HISTORIC AND DESIGN REVIEW COMMISSION

October 21, 2020

HDRC CASE NO:	2020-448
ADDRESS:	415 HAYS ST
LEGAL DESCRIPTION:	NCB 528 BLK 1 LOT 12
ZONING:	IDZ-1, H
CITY COUNCIL DIST.:	2
DISTRICT:	Dignowity Hill Historic District
APPLICANT:	Juan Fernandez/CVF LLC
OWNER:	CVF LLC
TYPE OF WORK:	New construction of 3, two story residential structures
OWNER:	CVF LLC

REQUEST:

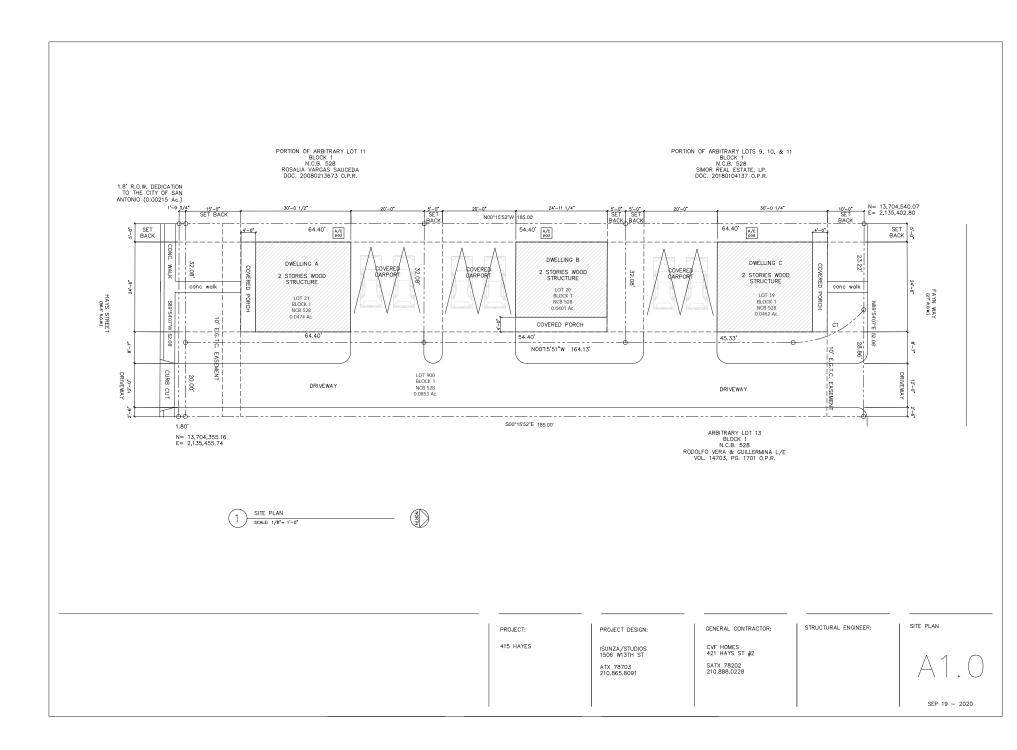
- d. SETBACKS & ORIENTATION (Hays) According to the Guidelines for New Construction, the front facades of new buildings are to align with front facades of adjacent buildings where a consistent

setback has been established along the street frontage. Additionally, the orientation of new construction should be consistent with the historic examples found on the block. The applicant has provided a site plan that notes a front setback (from the sidewalk) of approximately seventeen (17) feet. The applicant has not provided information in regards to how the proposed setback relates to the adjacent, historic structures. Staff finds that the proposed new construction should feature setbacks that are greater than or equal to those found historically on the block. The deepest historic setback should be referenced and used for determining an appropriate setback.

Staff does not recommend conceptual approval at this time. While staff finds the proposed massing of the southern structure to be appropriate, staff finds that the applicant should confirm that the setback of the proposed structure fronting Hays Street should be greater than those found historically on the block. Additionally, staff finds that the following items should addressed prior to conceptual approval:
